PLANS FOR THE CONSTRUCTION OF
 PAVING, BRIDGE, STORM SEWER, WATER, SANITARY SEWER
 SIGNALIZATION AND STREETScape IMPROVEMENTS FOR

ARAPAHO ROAD - PHASE III

FROM SURVEYOR BOULEVARD TO ADDISON ROAD

PROJECT RECORD COPY I

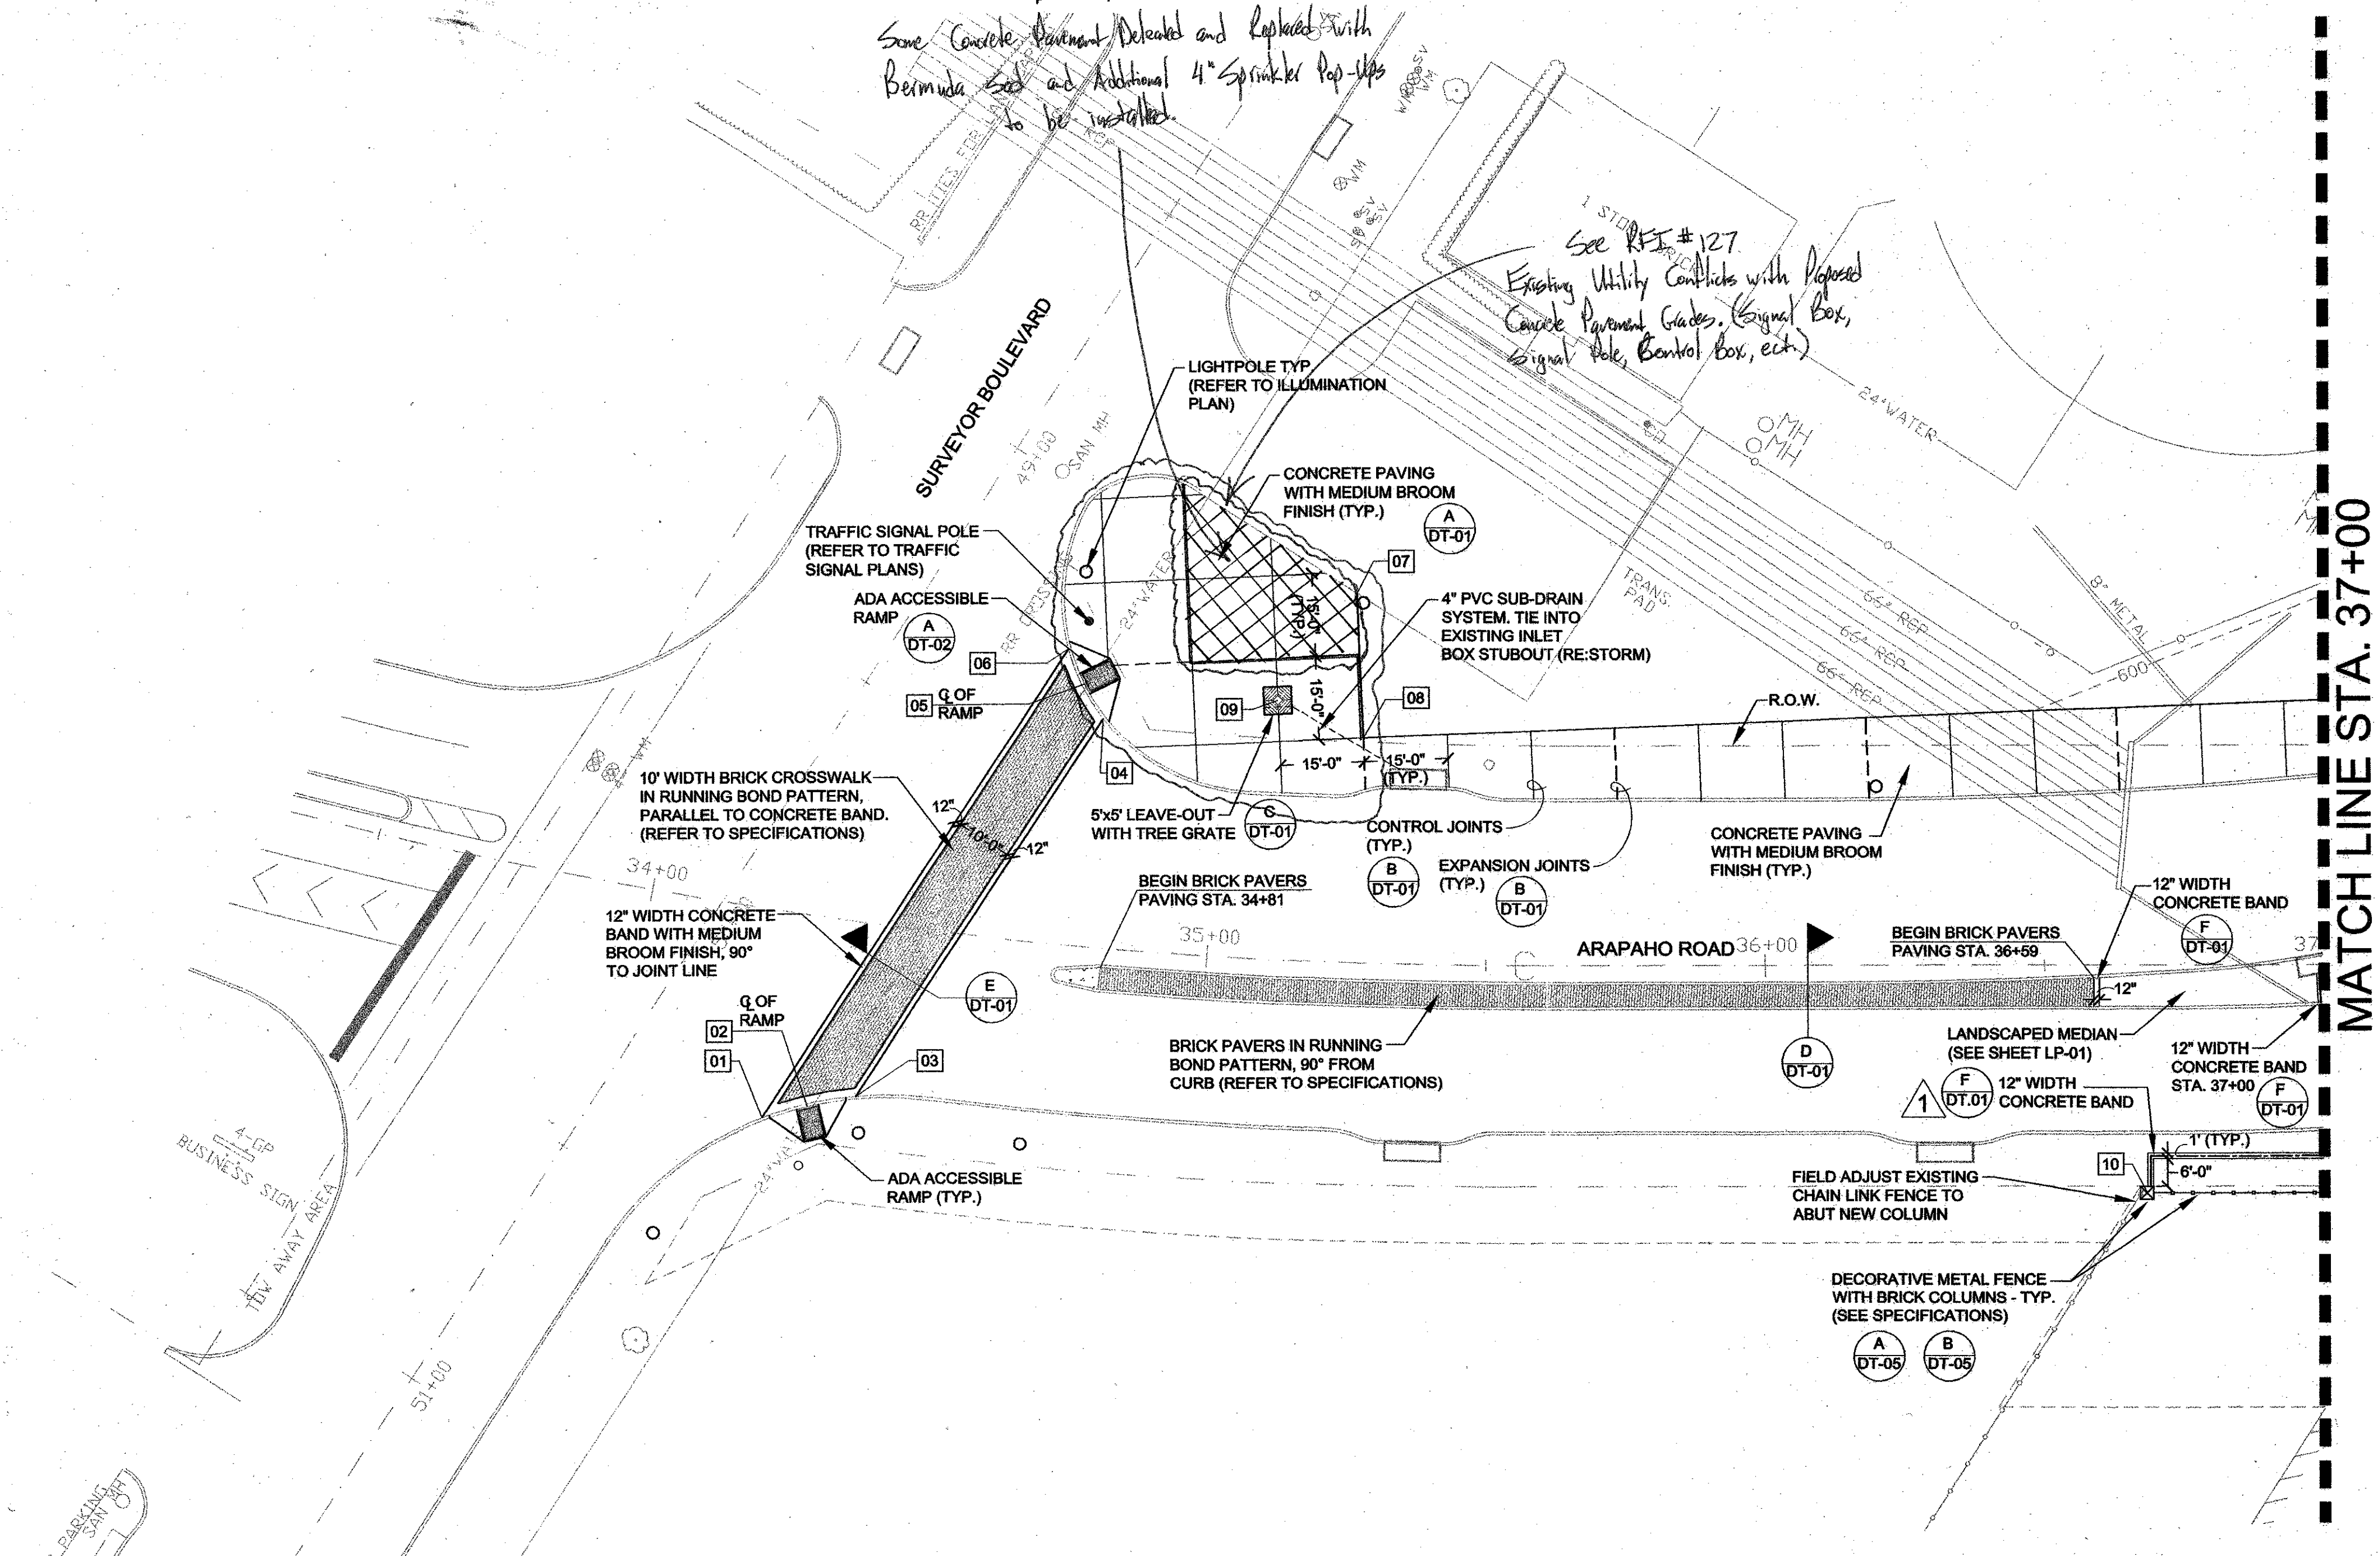
See HNTB Letter
 "Sitework @ NE Corner of Arapaho/Surveyor Blvd"
 Dated 11/3/05
 Some Concrete Pavement Deleted and Replaced with
 Bermuda Sod and Additional 4" Sprinkler Pop-Ups
 to be installed.

See RFI #127
 Existing Utility Conflicts with Proposed
 Concrete Pavement Grades, Signal Box,
 Signal Pole, Control Box, etc.

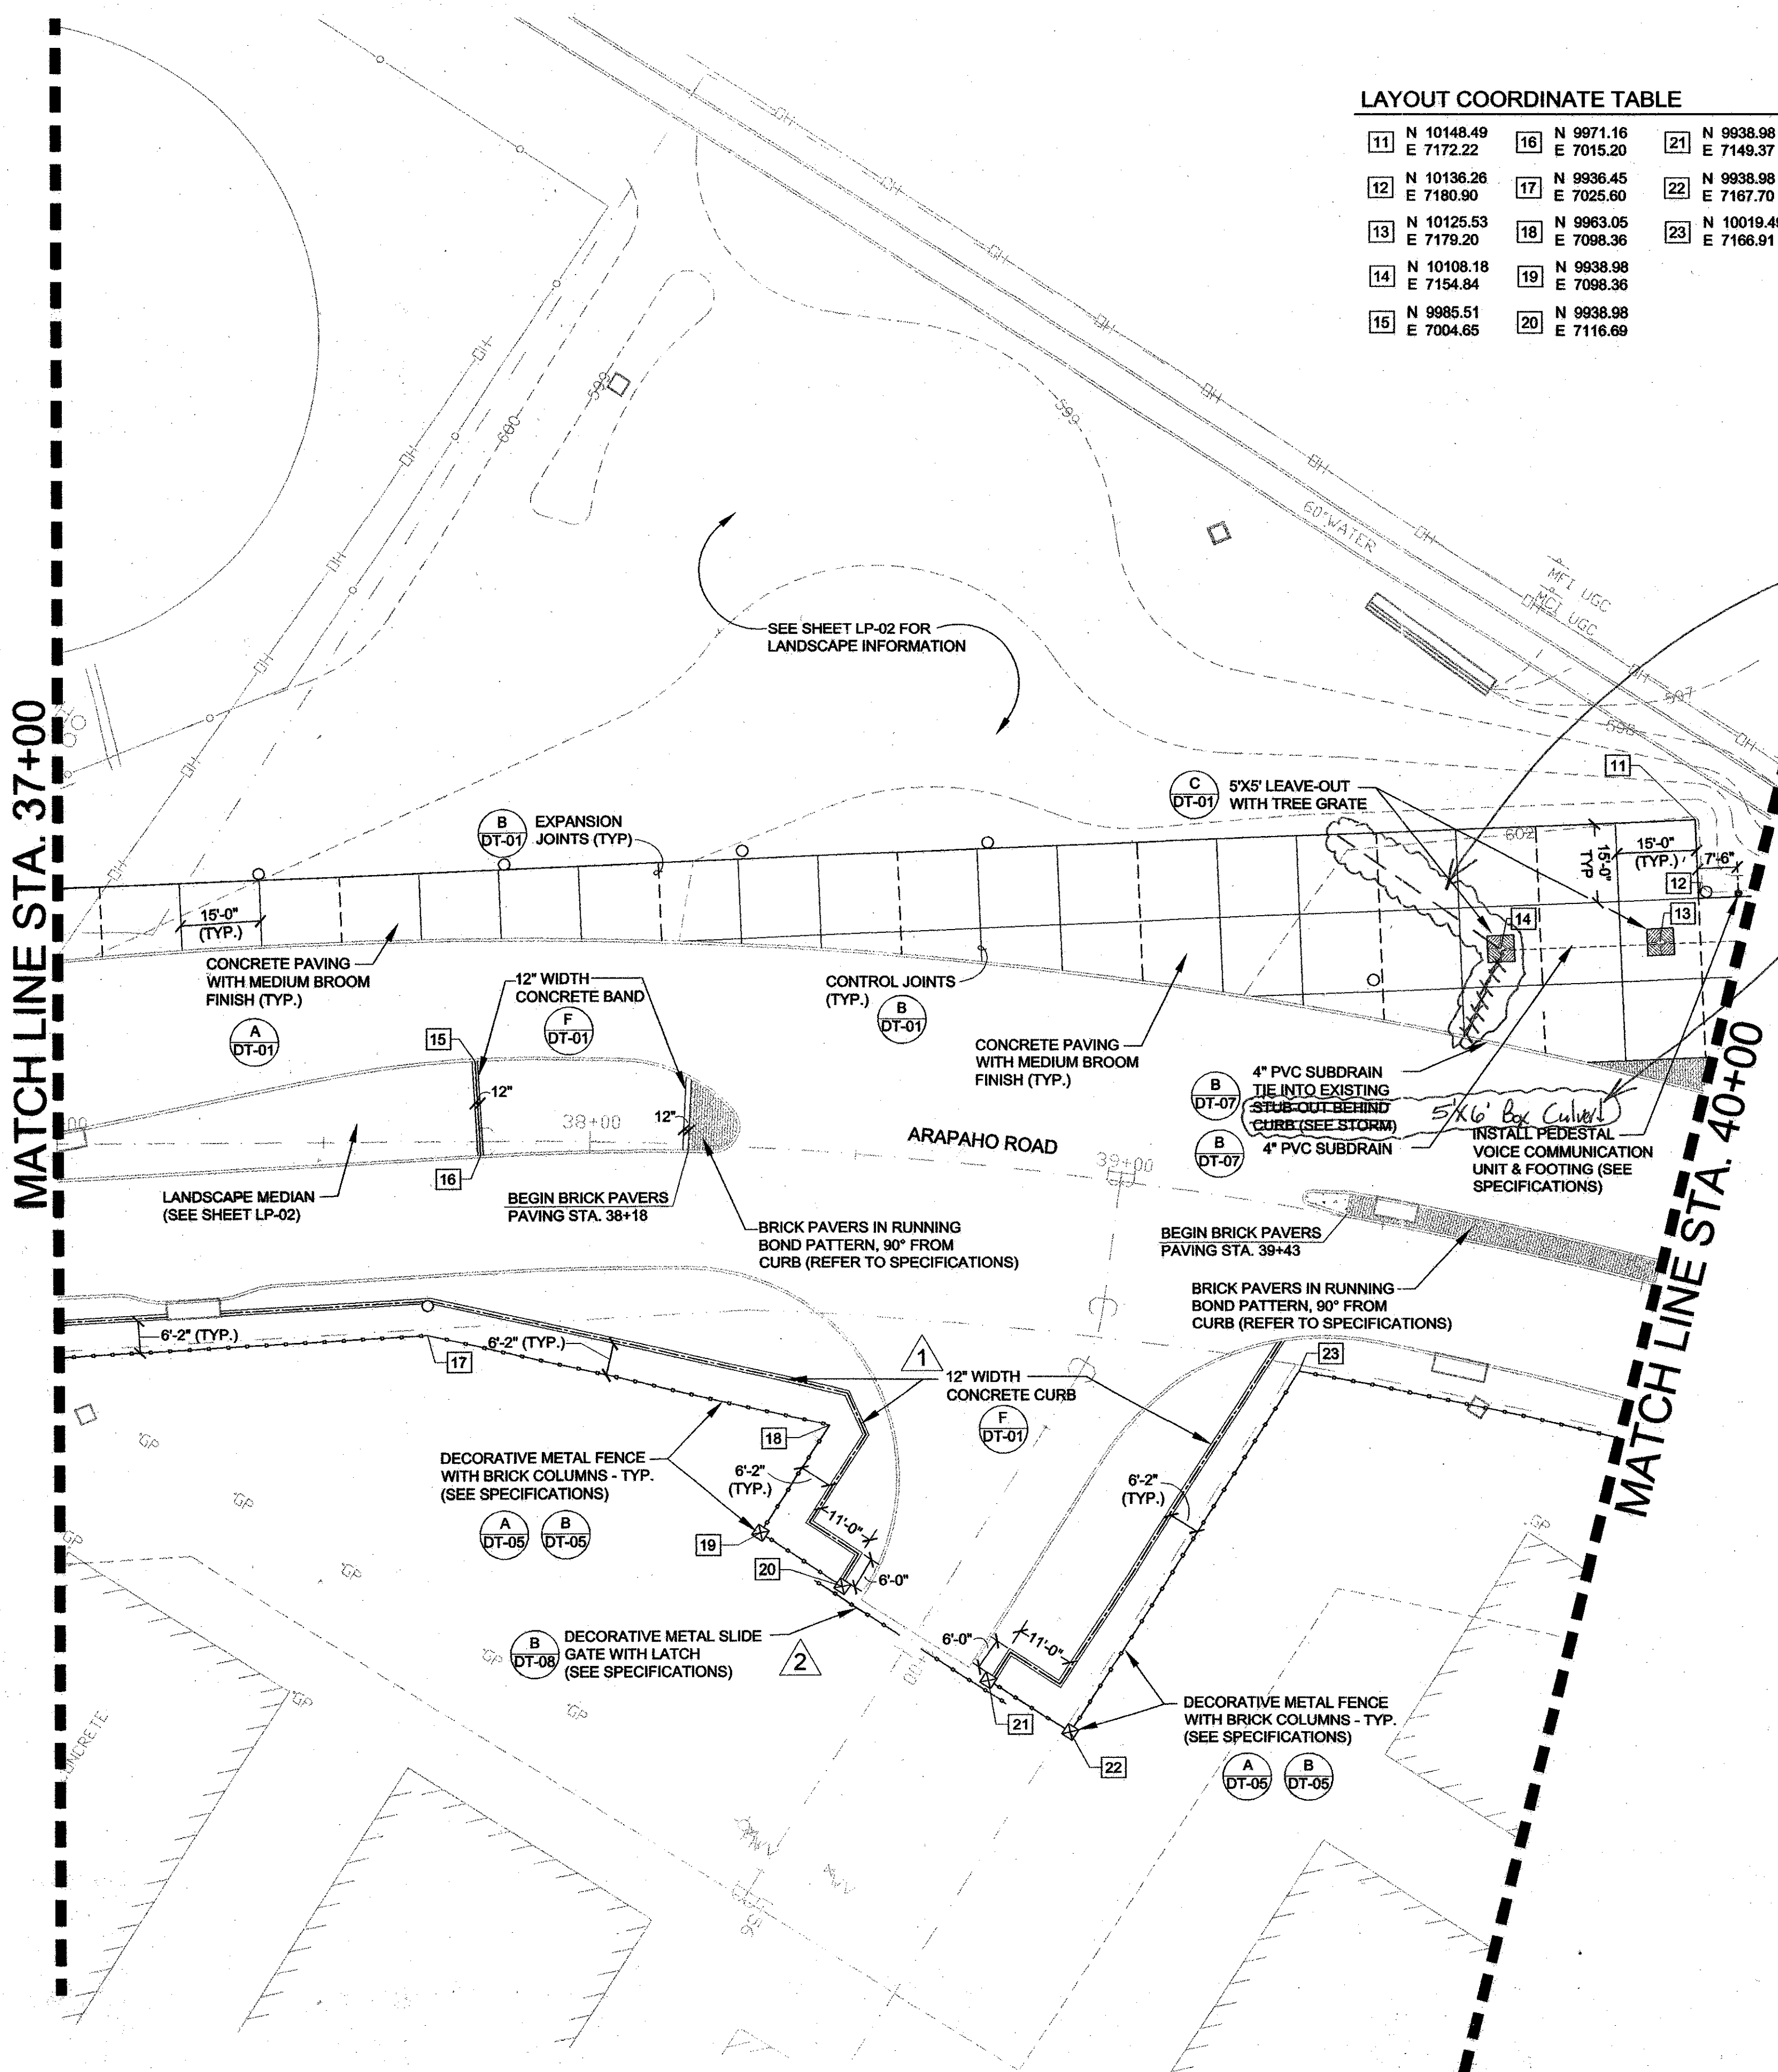
See RFI #043
Run 4" PVC Subdrain System in Trench into the 5'x6' Culvert. (Material B-2) Install 4" Pipe at Minimum of 1% Slope and connect to Box in the Upper 2' of the sidewalk.

ARAPAHO ROAD EXTENSION
SURVEYOR BOULEVARD TO ADDISON ROAD
STA 55+00 TO 60+00
SITWORK LAYOUT & DIMENSIONING PLAN
TOWN OF ADDISON, TEXAS

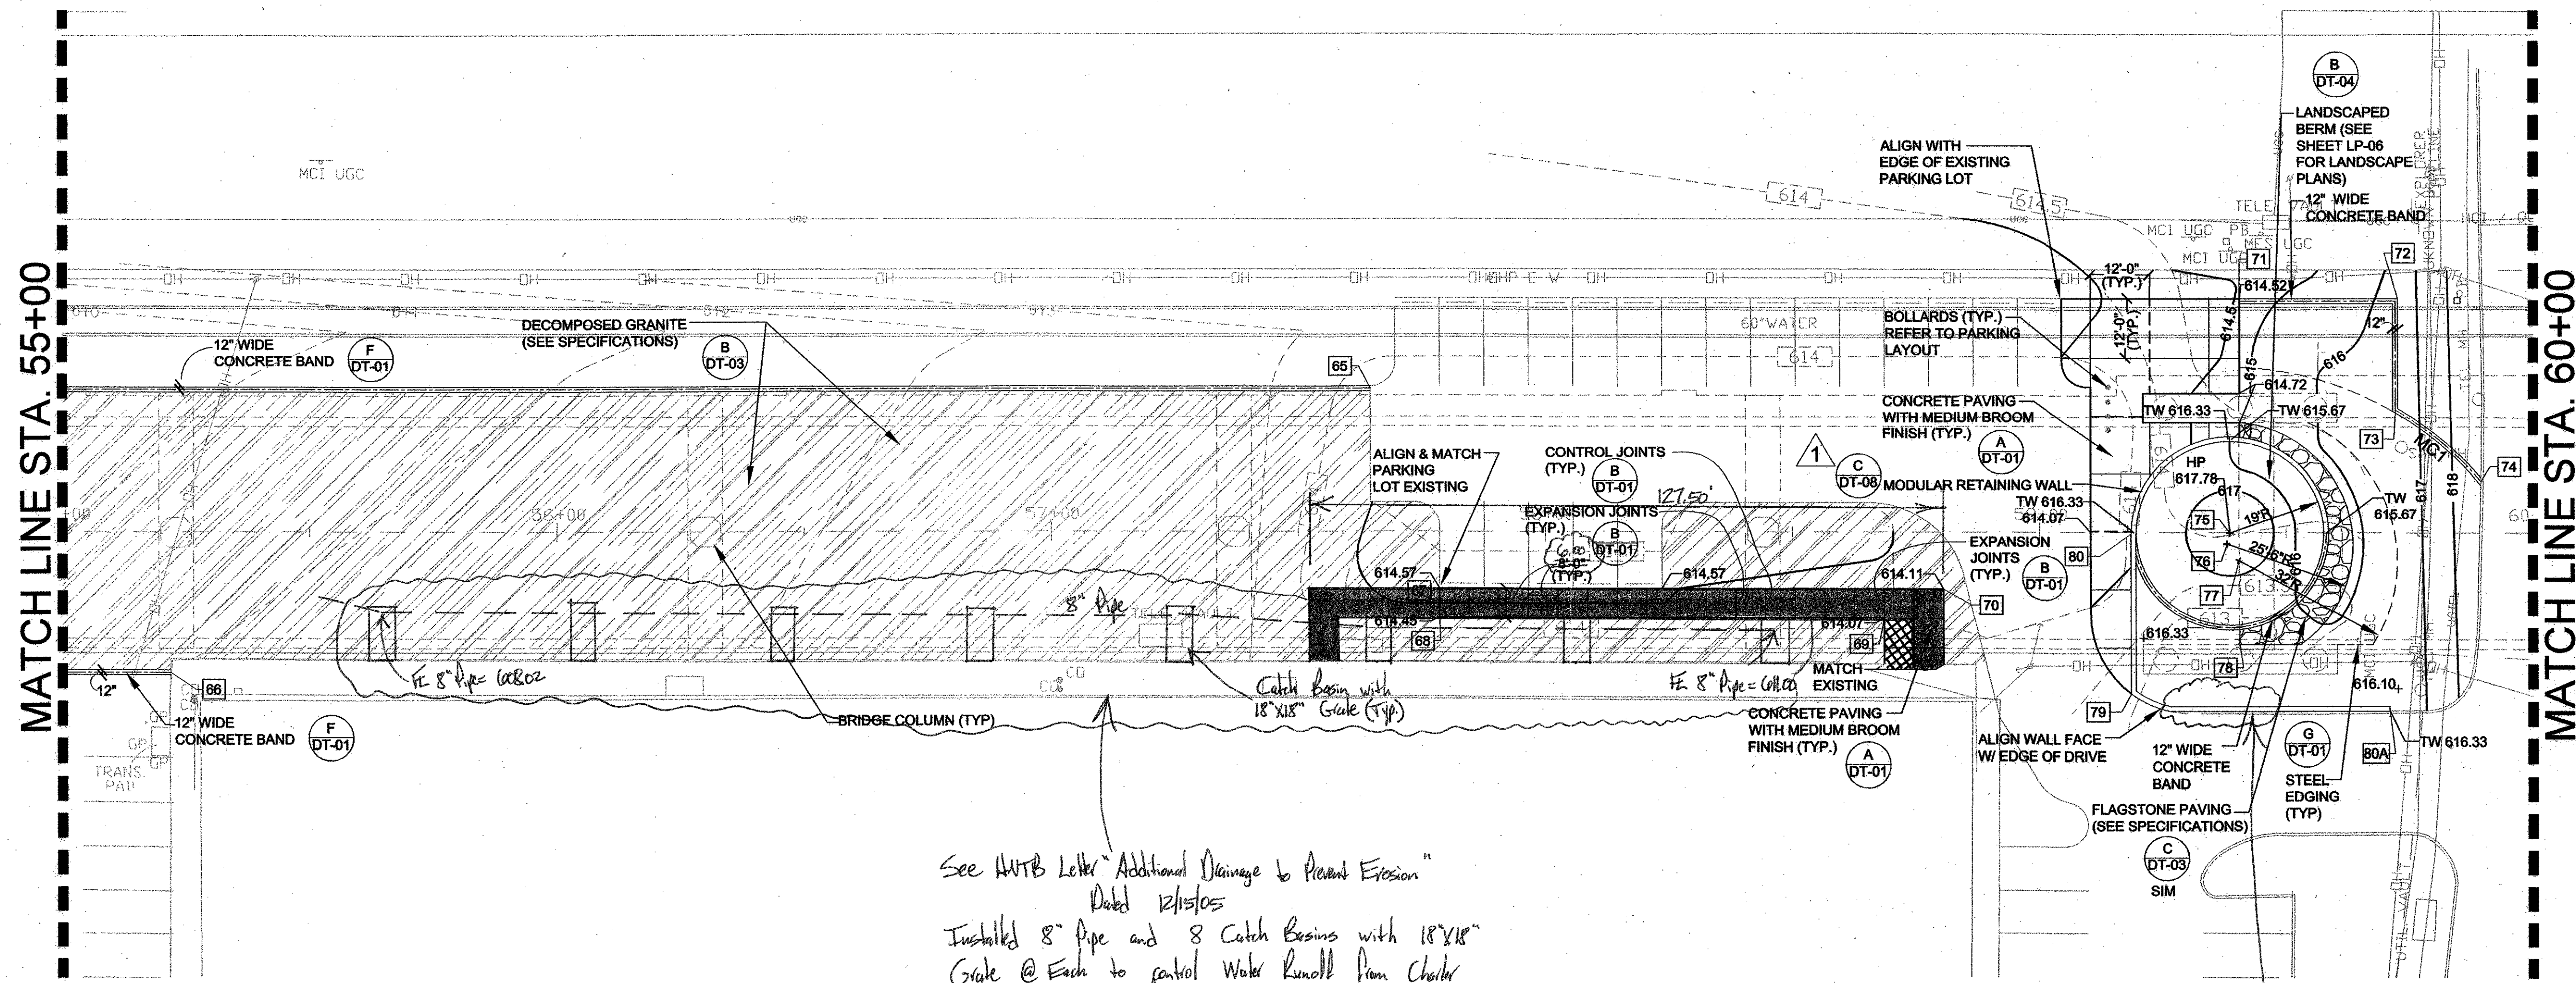
See RFI # 129
 Modular Wall shall be built around Inlet A-5B. The 200 wide level pad will be reduced to 150' to place Black Blush with North Side of Inlet.
